MONTGOMERY COUNTY HISTORIC PRESERVATION COMMISSION
STAFF REPORT

Address:	511 Philadelphia Ave., Takoma Park	Meeting Date:	3/6/2024
Resource:	Contributing Resource Takoma Park Historic District	Report Date:	2/28/2024
Applicant:	Christopher Khoury Megan DiNicola, Architect	Public Notice:	2/21/2024
Review:	HAWP	Tax Credit:	Partial
Case Number:	1054004	Staff:	Dan Bruechert
Proposal:	Partial Demolition, Rear Addition, Fenestration Alteration, and Roof Replacement

Figure 3: Proposed left elevation showing the proposed window openings.

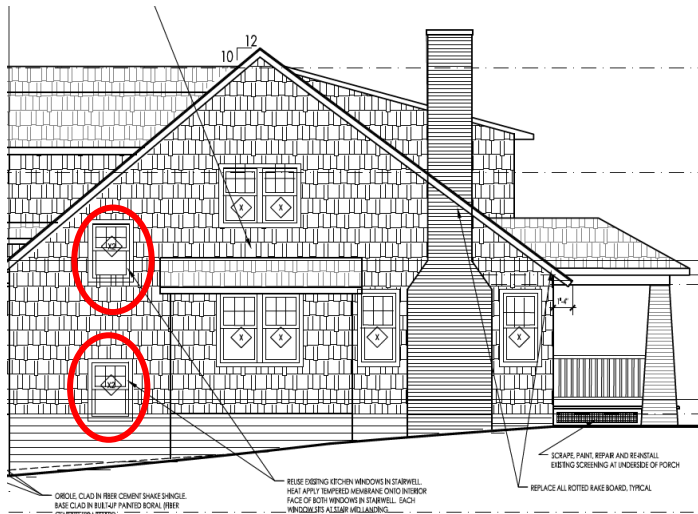
The applicant proposes to retain two six-over-one sash windows from the rear wall and install them on the left elevation towards the rear to provide illumination to the new interior stair (see *Figure 3*, below).

Staff finds the proposed windows will be removed to accommodate the proposed addition, discussed above and their removal will not have a negative impact on the character of the resource or surrounding district. Staff further finds installing the windows will not detract from the house's character. While one could find that installing the windows creates a false sense of history, Staff believes that the change is generally consistent with the architectural character and period of the resource, as outlined in the *Design Guidelines*. Staff recommends the HPC approve the window relocation under 24A-8(b)(2) and (d) and the *Design Guidelines*.

Figure 4: 1927 Sanborn Fire Insurance Map showing the subject property with a full-width front porch.

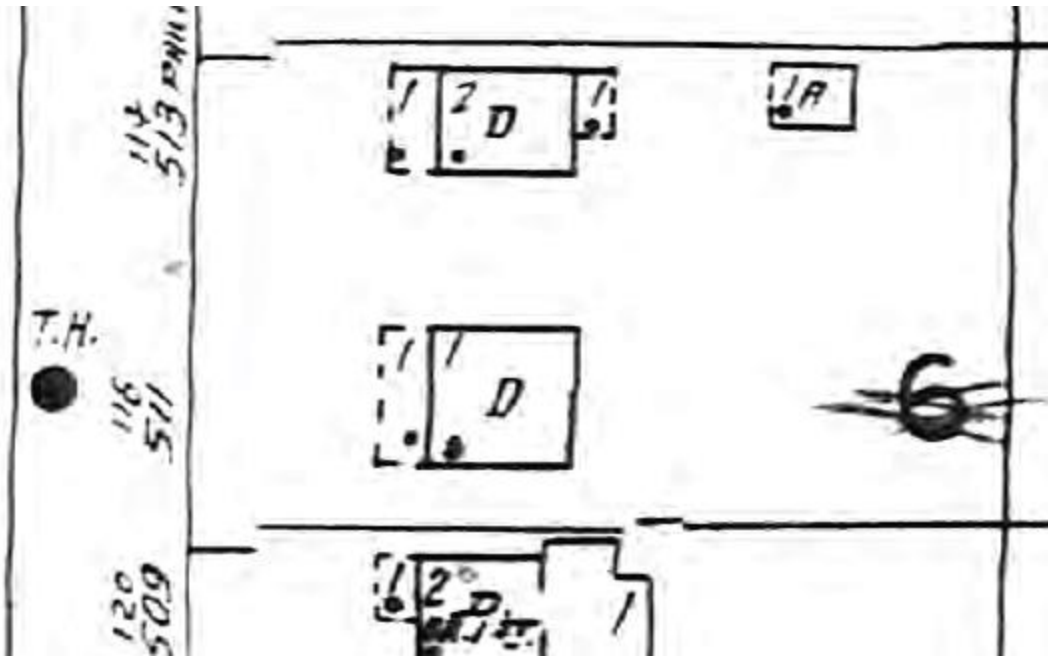
The front of the house has two pairs of six-over-one windows with a central door. The front elevation is partially obscured by a partial-width front porch with a hipped roof supported by battered brick columns. Based on the 1927 Sanborn map, this porch is a later modification from the original full-width front porch (see Figure 4, below).

Figure 5: Existing condition (left) and proposed rearranged front (right).

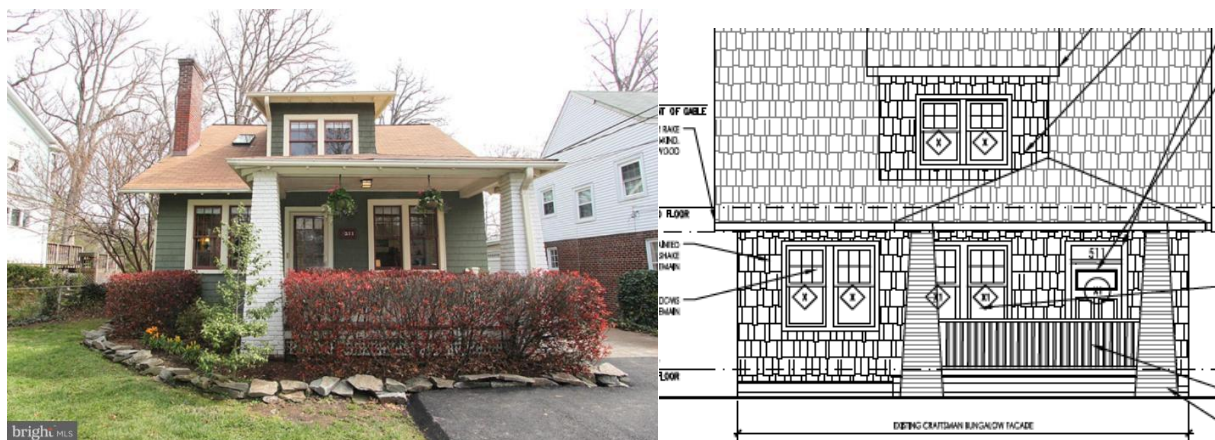
The applicant proposes to swap the front door and the right pair of windows. This change is proposed to accommodate a revised interior plan. The *Design Guidelines* include, “Additions and alterations to the first floor at the front of a structure are discouraged, but not automatically prohibited” and further states, “Original size and shape of window and door openings should be maintained, where feasible.” The *Guidelines* do not state in what circumstances alterations on the front of the first floor should be allowed, however, Staff does not find that converting a symmetrical façade to an asymmetrical façade is appropriate under either the *Design Guidelines* or 24A-8(b)(1) and (2). Staff rejects the an assertion that the second guideline quoted means that the fenestration alteration should be allowed provided the door and window size does not change.

Staff recommends the HPC adopt a condition that the approval of the HAWP does not extend to the proposed alterations to the façade.
